Calvert Cliffs Nuclear Power Plant, Unit Nos. 1 and 2
Renewed Facility Operating License Nos. DPR-53 and DPR-69
NRC Docket Nos. 50-317 and 50-318

Subject: Response to Request for Additional Information Regarding Atmospheric Dump Valves License Amendment Request

**RESPONSE TO REQUEST FOR ADDITIONAL INFORMATION FOR
ATMOSPHERIC DUMP VALVES**

Drawings of the ADV Valve Body, Operator

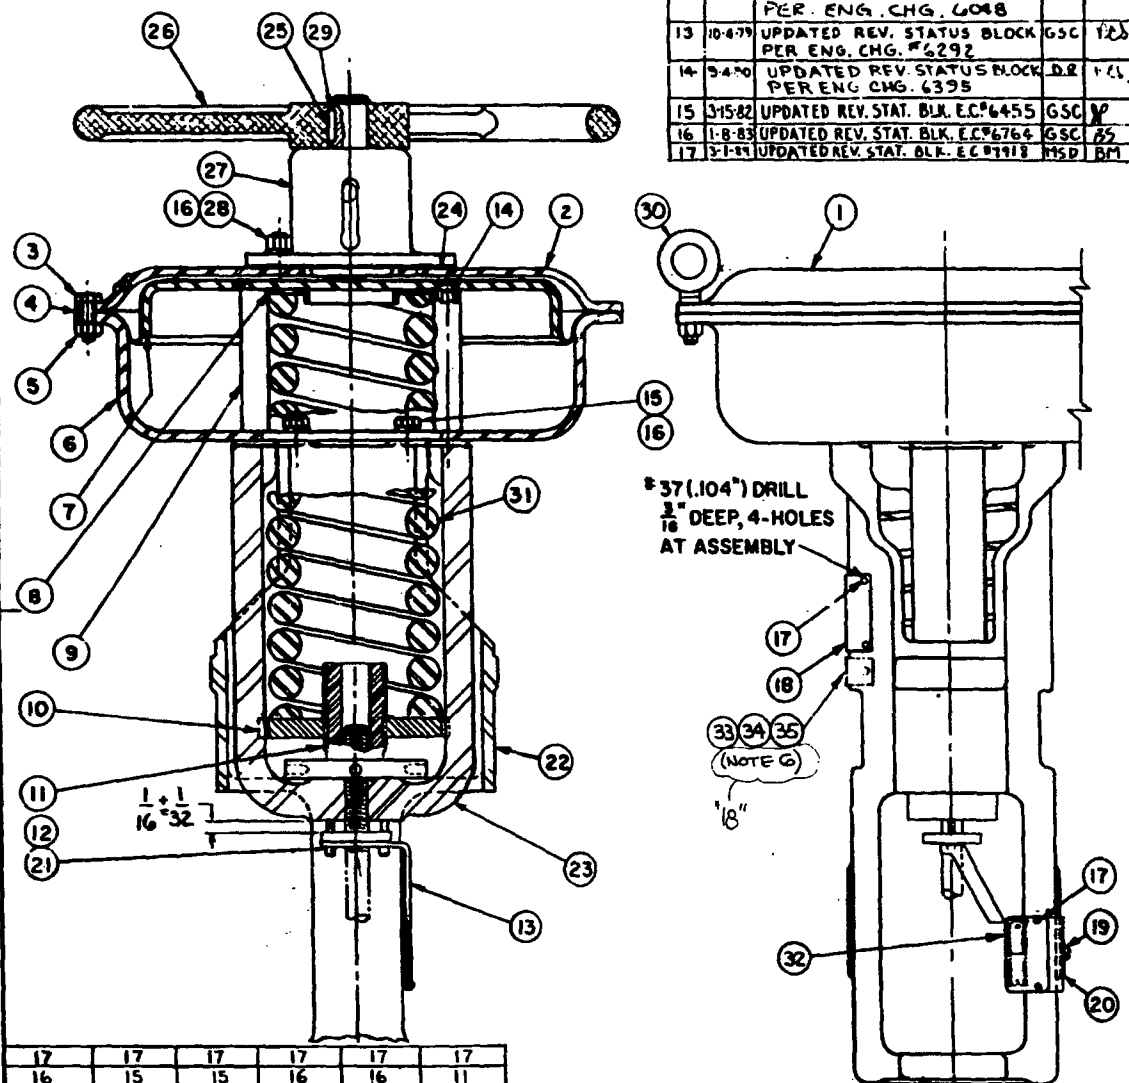
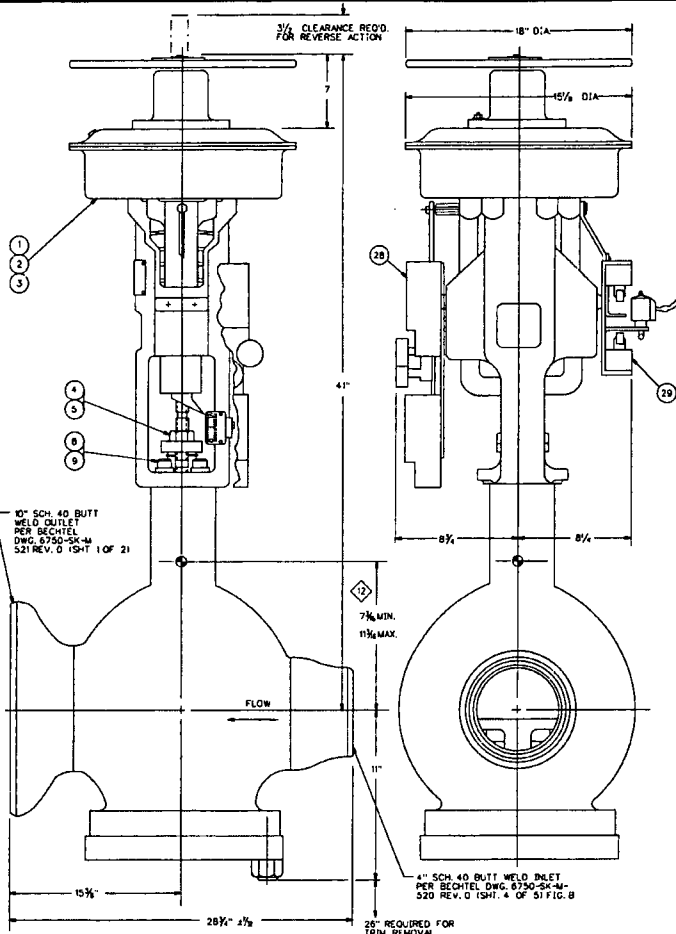
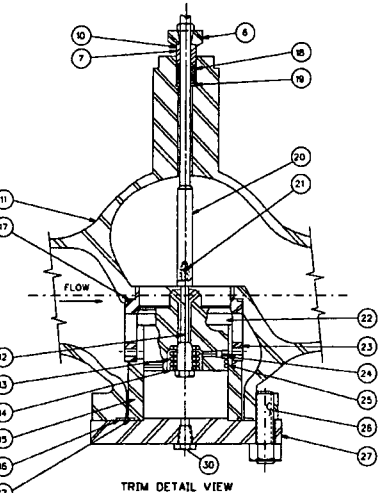
A drawing of the ADV valve body has been attached for reference (Enclosure 1). The ADV stem travels in the downward direction, into the steam space to open the valve. The valve is equipped with a pilot to assist in initial opening.

A drawing of the ADV valve operator has been attached for reference (Enclosure 1). The ADV is an air-to-open, fail closed, valve. Air is applied to the top of the valve diaphragm in order to lower the valve stem, and open the valve. Air acts against the large spring (item #31), compressing it, in order to open the valve. With no air on the diaphragm, the spring forces the valve shut.
